Access Compliance Report

Public Rights-of-Way

(Curb Ramps)

Intersection ID: 14053	Main Street: AMAY_JAMES_AV	Cross Street: WEST_BV	Location: SW
ADA ID: BBA44E17F82F	Ramp Type: Perp	Initial Pass/Fail: Fail	Overall Compliance: No
Severity Score: 12.5			
Codes/Mitigation Info/Possible Solution		Field Measurements/Component Compliance

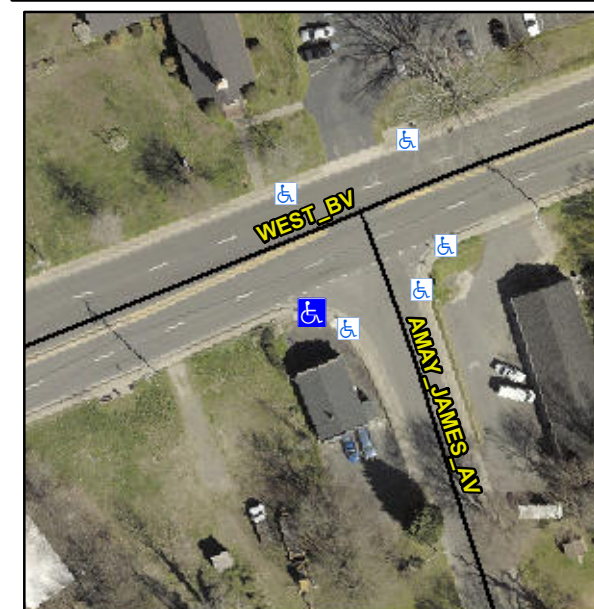
Not Found, R304.2.2

Compliance	Description	Data	Compliance	Description	Data
N/A	Ramp Length (in)	72.0	No	Ramp Slope (%)	9.1
Yes	Ramp Width (in)	48.0	Yes	Ramp XSlope (%)	1.7
N/A	Flare Type LT	N/A	N/A	Flare Type RT	N/A
N/A	Flare Slope LT (%)	N/A	N/A	Flare Slope RT (%)	N/A
N/A	Flare Traversable LT?	N/A	N/A	Flare Traversable RT?	N/A
N/A	Landing Length (in)	N/A	N/A	DWS Provided?	N/A
N/A	Landing Width (in)	N/A	N/A	DWS Contrast?	N/A
N/A	Landing Slope (%)	N/A	N/A	DWS Length (in)	N/A
N/A	Landing X Slope (%)	N/A	N/A	DWS Full Width?	N/A
N/A	Landing Curb? (Y/N)	N/A	N/A	DWS Offset (in)	N/A
N/A	Shared Landing?	N/A			
N/A	Gutter Ponding?	N/A	N/A	Gutter Slope (%)	N/A
N/A	Gutter Lip Ht (in)	N/A	N/A	Gutter X Slope (%)	N/A
N/A	Painted X Walk1?	No	N/A	Painted X Walk2?	N/A
	X Walk 1 Direction	To N		X Walk 2 Direction	N/A
N/A	X Walk 1 Width (in)	N/A	N/A	X Walk 2 Width (in)	N/A
	X Walk 1 Slope (%)	1.2		X Walk 2 Slope (%)	N/A
	X Walk 1 X Slope (%)	0.7		X Walk 2 X Slope (%)	N/A

Remove & Replace Entire Ramp.
